Access Compliance Report

Public Rights-of-Way

(Curb Ramps)

Intersection ID: 49333	Main Street: MARGARET_WALLACE_RD	Cross Street: MINTWORTH_AV	Location: NW
ADA ID: 2B87C4A41737	Ramp Type: PerpDiag	Initial Pass/Fail: Fail	Overall Compliance: No
Severity Score: 13.75			
Codes/Mitigation Info/Possible Solution		Field Measurements/Component Compliance

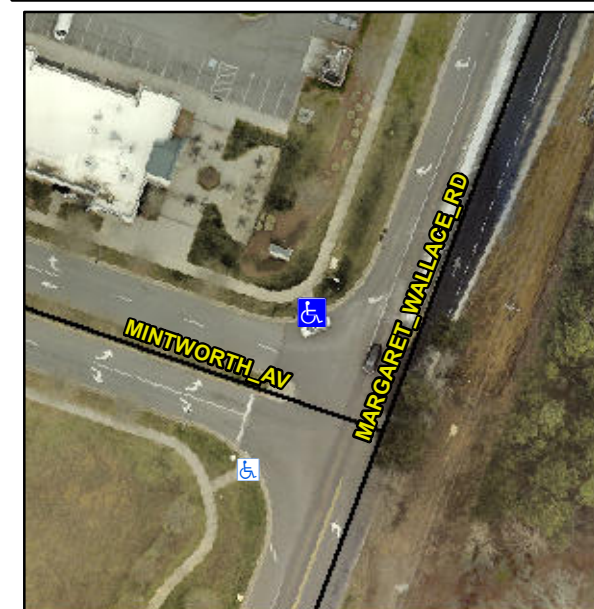
Not Found, R304.2.2, R304.5.3

Compliance	Description	Data	Compliance	Description	Data
N/A	Ramp Length (in)	48.0	No	Ramp Slope (%)	9.2
Yes	Ramp Width (in)	48.0	No	Ramp XSlope (%)	4.7
N/A	Flare Type LT	N/A	N/A	Flare Type RT	N/A
N/A	Flare Slope LT (%)	N/A	N/A	Flare Slope RT (%)	N/A
N/A	Flare Traversable LT?	N/A	N/A	Flare Traversable RT?	N/A
N/A	Landing Length (in)	N/A	N/A	DWS Provided?	N/A
N/A	Landing Width (in)	N/A	N/A	DWS Contrast?	N/A
N/A	Landing Slope (%)	N/A	N/A	DWS Length (in)	N/A
N/A	Landing X Slope (%)	N/A	N/A	DWS Full Width?	N/A
N/A	Landing Curb? (Y/N)	N/A	N/A	DWS Offset (in)	N/A
N/A	Shared Landing?	N/A			
N/A	Gutter Ponding?	N/A	N/A	Gutter Slope (%)	N/A
N/A	Gutter Lip Ht (in)	N/A	N/A	Gutter X Slope (%)	N/A
N/A	Painted X Walk1?	No	N/A	Painted X Walk2?	No
	X Walk 1 Direction	To SW		X Walk 2 Direction	To SE
N/A	X Walk 1 Width (in)	N/A	N/A	X Walk 2 Width (in)	N/A
	X Walk 1 Slope (%)	0.8		X Walk 2 Slope (%)	5.3
	X Walk 1 X Slope (%)	5.6		X Walk 2 X Slope (%)	0.7

Remove & Replace Curb Ramp With Two New Directional Ramps or Equivalent.
